010. Letter from Central City Association, dated February 10, 2017

011. Letter from Climate Action Reserve, dated February 8, 2017

OVERALL LAND USE PLAN STATISTICAL TABLE
Newhall Ranch Specific Plan

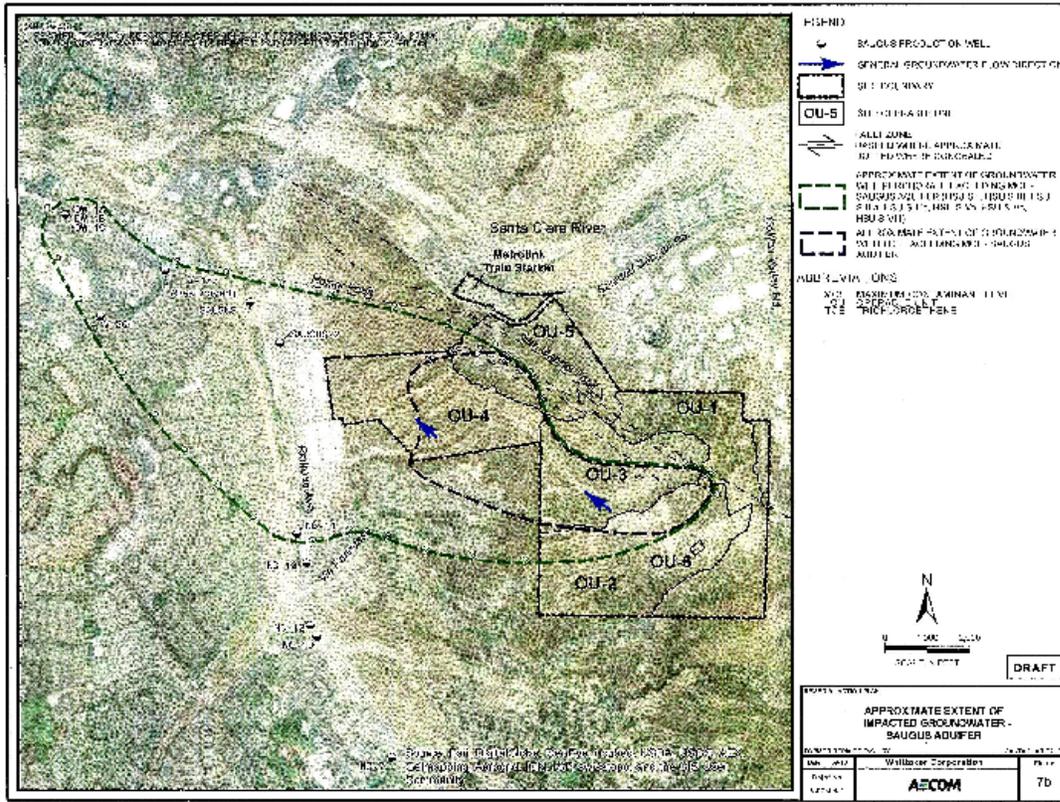
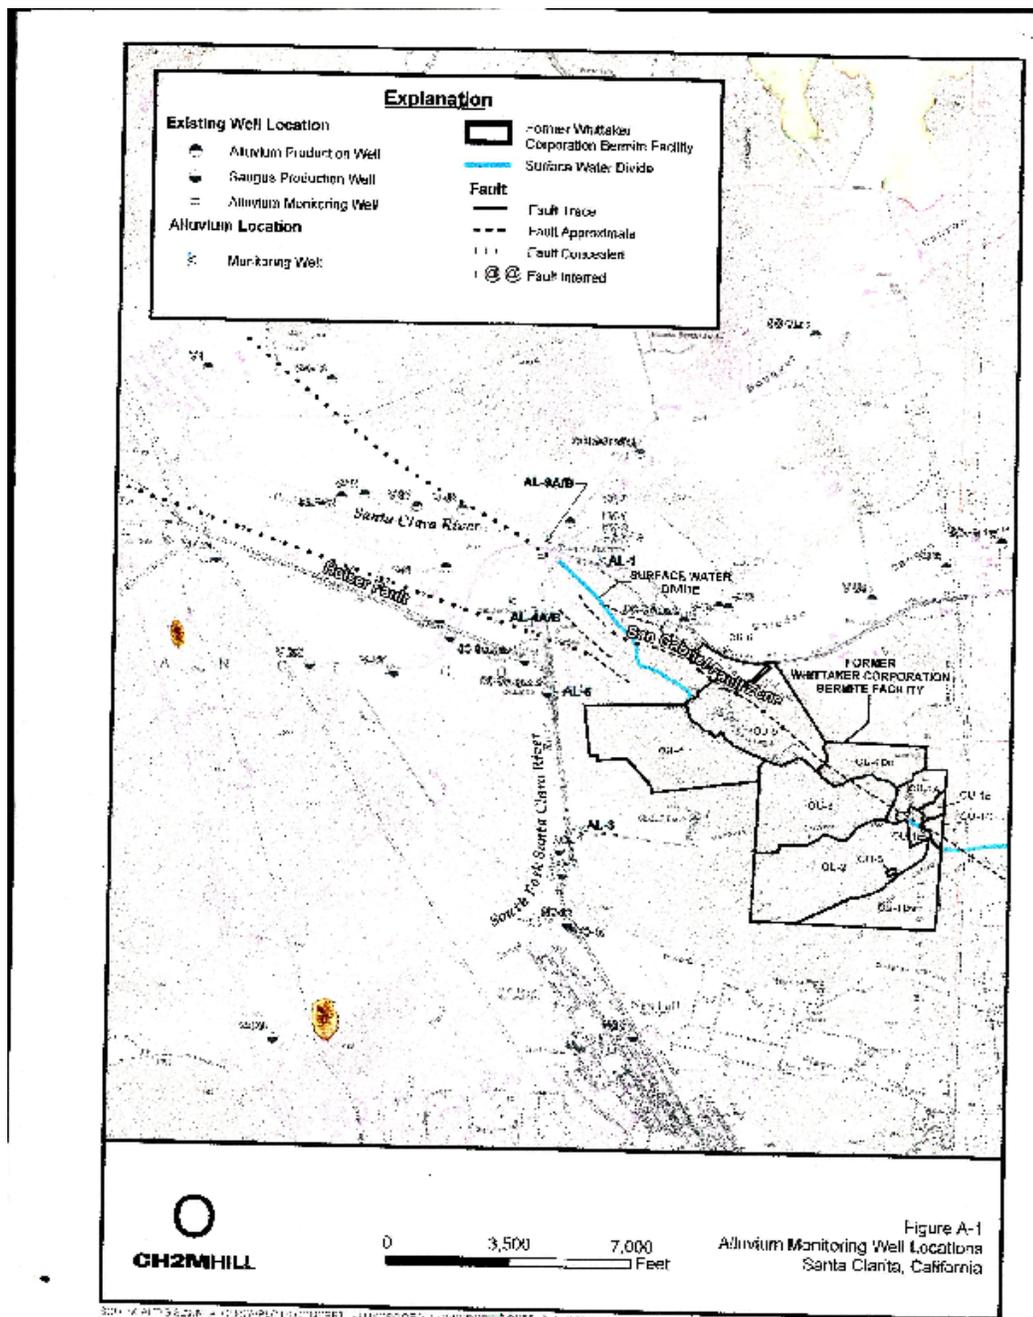
When the Newhall Ranch Specific Plan was approved in 2003, the approved unit number was 21,308 (Table attached as Exhibit 1). The table 1.2.1 on page 1-6 includes only 19, 517 units and adds another 1725 for the Entrada projects which were not included in the Specific Plan. While, it is our understanding that some units were removed from the Landmark project in the last review, to our knowledge it was NOT the nearly 2000 units indicated by this table. Please explain this discrepancy.
